Central Valley Regional Water Quality Control Board

ORDER AMENDING CLEAN WATER ACT SECTION 401 TECHNICALLY CONDITIONED WATER QUALITY CERTIFICATION; CALIFORNIA DEPARTMENT OF TRANSPORTATION, STATE ROUTE 4 WAGON TRAIL REALIGNMENT PROJECT (WDID#5B05CR00093A1), CALAVERAS COUNTY

Figure 1 – Previously Certified Design Map (Subproject 6)

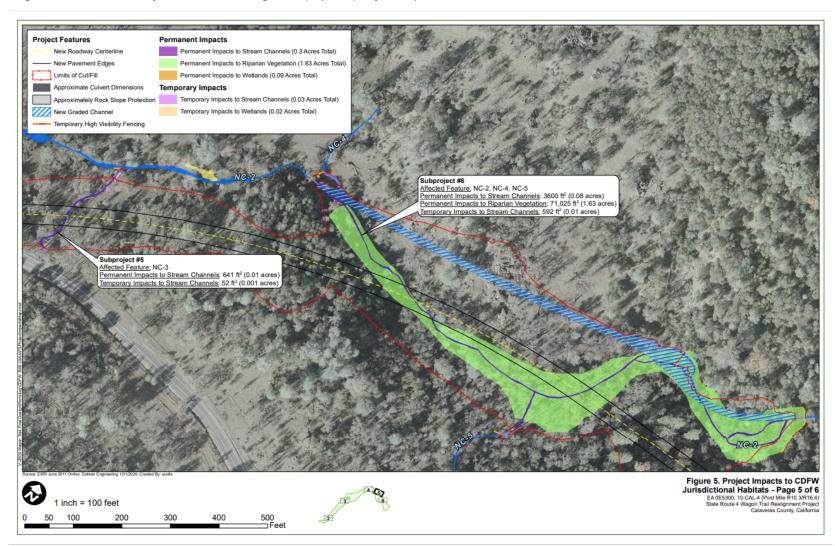
The California Department of Transportation (Caltrans) is requesting a change to a portion of the Project description and Project design. The redesign applies to Subproject 6, as identified in the original Project description, which includes realigning a segment of Nassau Creek. Figure 1 shows the previously Certified engineered channel path, and Figure 2 shows the proposed new path for the engineered channel. Impact acreage has not changed with the Project redesign. The Project redesign will allow Caltrans to proceed with the Project while avoiding cultural resources identified during initial stages of construction.

Subproject 6: Nassau Creek will remain entirely on the north side of the new roadway. A linear portion of Nassau Creek will be realigned into an engineered channel. One segment of Nassau Creek, located in close proximity to the new roadway, will be converted to a U-shaped concrete lined channel. The U-shaped channel will be approximately 135 linear feet, and 6 feet deep by 6 feet wide, and will include embedded rocks.

Approximately 640 cubic yards of rock slope protection will be installed at the beginning and end of the U-shaped channel to help prevent erosion.
